AMENDMENT NO. 2 JUNE 1991
TO
IS 6071 : 1986 SPECIFICATION FOR
SYNTHETIC SEPARATORS FOR LEAD-ACID
BATTERIES
(first Revision)

FIG. 9 SEPARATOR IMPACT Test APPARATUS

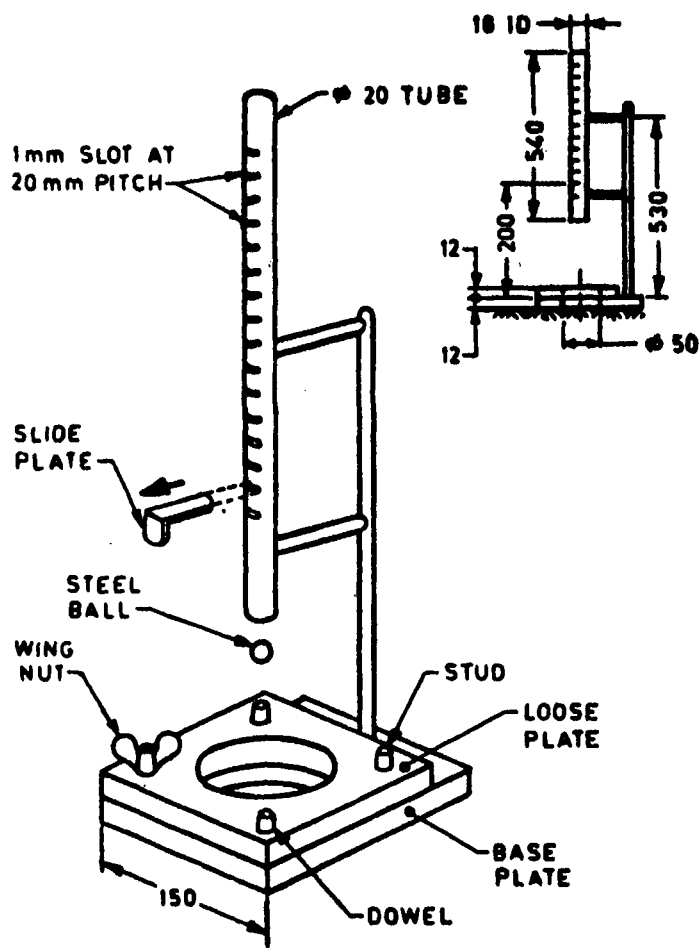
(Page 20, clause G-1.3) — Insert the following Appendix at the end:

A P P E N D I X H
(Clause 13.1)

MECHANICAL STRENGTH TEST

H-1 The specimen separator shall be clamped in the jig with ribs, if any, being on the lower side (*see* Fig. 9).

H-2 A steel ball of 12.7 mm dia weighing 8.3 ± 0.2 g is dropped vertically from a height of 200 mm.

NOTE — The tube shall be so adjusted that the steel ball falls between the ribs, if any, of the separator (ribs facing downwards).
